Aviation Investigation Report AIR-25-02

Address Noncompliant Evacuation Slide Components on Boeing Airplanes

Figure 2. Boeing SB 757-25A0058 modifications of slide pack release cable assembly required by AD 86-09-09. (Source: Image Copyright © Boeing. Reproduced with permission.)

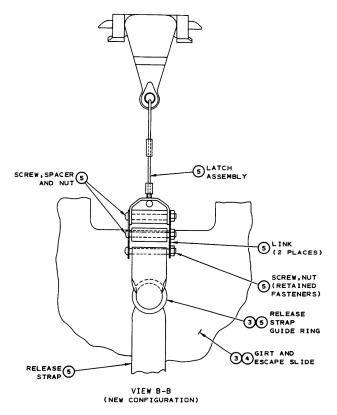
Boeing Service Bulletin (SB) 757-25A0058, dated April 18, 1986 (see figure 2).⁴ Instead, the R1 bannis latch on the accident airplane had only one link and lacked other required hardware (see figure 3), which caused the slide pack to jam before the jumpseat occupant was eventually able to force the door to open. Postaccident examination of the L1 door found that, although its bannis latch conformed to required modifications, the deployment strap was incorrectly routed, which prevented the door from opening.

Figure 4. Boeing 757 bannis latch configuration in the FedEx AMM (left) and Boeing AMM (right). (Source: Image Copyright © Boeing. Reproduced with permission.)

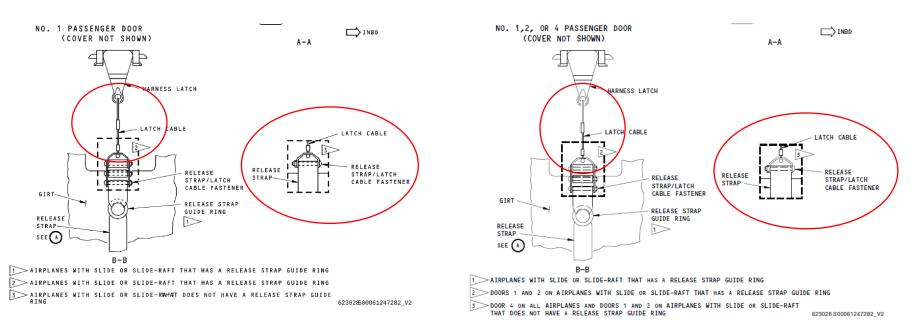
The NTSB's review of the Boeing 757 and FedEx aircraft maintenance manuals (AMMs) and the Boeing illustrated parts catalog (IPC) found that all contained inconsistent depictions of the bannis latch configuration as required by ADs 86-09-09 and 2001-15-01. For example, the illustrations shown in figures 4 and 5 depict different versions of the release assembly and both the three- and one-link configurations, circled on each illustration. Both illustrations in figure 4 indicate a cable rather than the required chain, and the inset image to the right of each full image indicates a single link rather than the required three links. The illustration from the Boeing IPC in figure 5 displays both the chain configuration (correct) and the cable and thimble configuration (incorrect), and both the single-link configuration (incorrect) and the three-link configuration (correct). It is also noted that Boeing does not have a single part number that covers the entire latch assembly. The current part number includes both the one-link and the three-link configurations.

None of these resources depict the bannis latch with all required modifications. These inconsistent, conflicting depictions would likely be confusing to maintenance personnel and could lead to the installation of and failure to detect nonconforming latches, which could result in another incident of an evacuation slide not deploying properly when needed. After the NTSB urged Boeing to look into the high incidence of noncompliant in-service bannis latches that were identified during FedEx's fleet inspection, Boeing's revision groups for the 757 AMM and IPC reached a consensus that the correct hardware for the bannis latch assembly could be clarified. Boeing anticipates releasing updates to the AMM and IPC in May 2025 to provide a consistent and accurate depiction of the bannis latch assembly.

Require all Boeing 757 operators to update their Boeing 757-200, -200CB, and -300 series airplane aircraft maintenance manuals (AMM) in accordance with the revised Boeing AMM and illustrated parts catalogs. (A-25-5)
